SERVICE BULLETIN RELEASE - 11/11/2014

04-005/14 - 2014-2015 MAZDA3 - SQUEAK NOISE FROM FRONT BRAKES AND/OR GROOVE MARKS ON FRONT DISC PLATE

Subject: SQUEAK NOISE FROM FRONT BRAKES AND/OR GROOVE MARKS ON FRONT DISC PLATE	Bulletin No: 04-005/14
	Last Issued: 11/11/2014

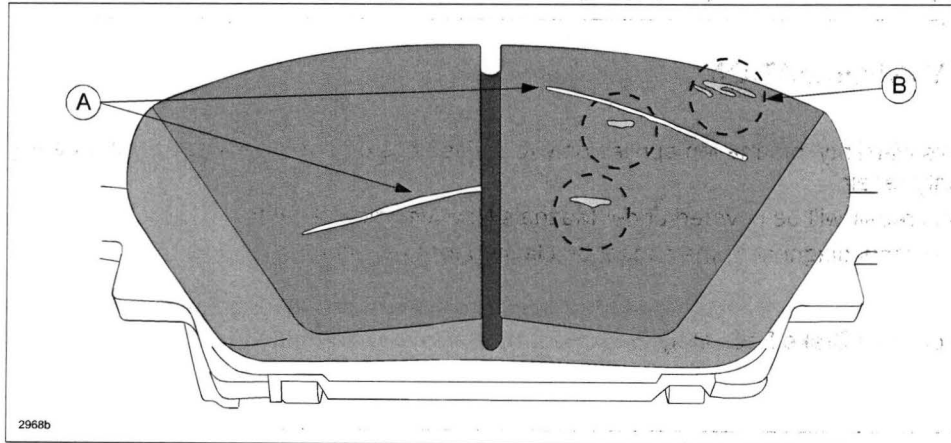
Some vehicles may exhibit a squeak noise when applying the brakes and/or groove marks (A) on the front disc plates. This is caused by abrasive metal from the front disc plate sticking to the brake pad, which damages the disc plate over time. To correct the problem, a modified brake pad is being used.

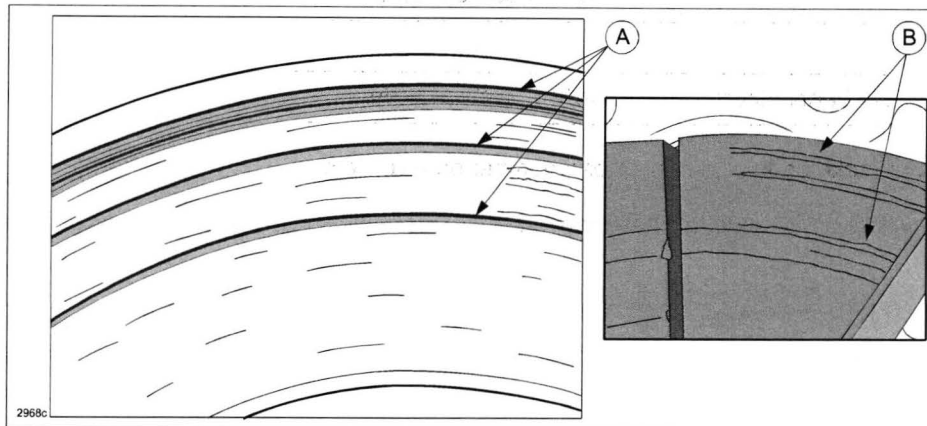
- If metal pieces (silver or white in color) are found in a line (A) or cluster form (B) on the surface, replace the front brake pads with a modified service set.

- If groove damage is found on a disc plate (A) and brake pad (B), replace the front brake pads with a modified service set and ONLY the damaged disc plate(s).

NOTE: Metal may have dropped off the brake pad, and groove damage will be found on the brake pad in the same position as damage on the disc plate.
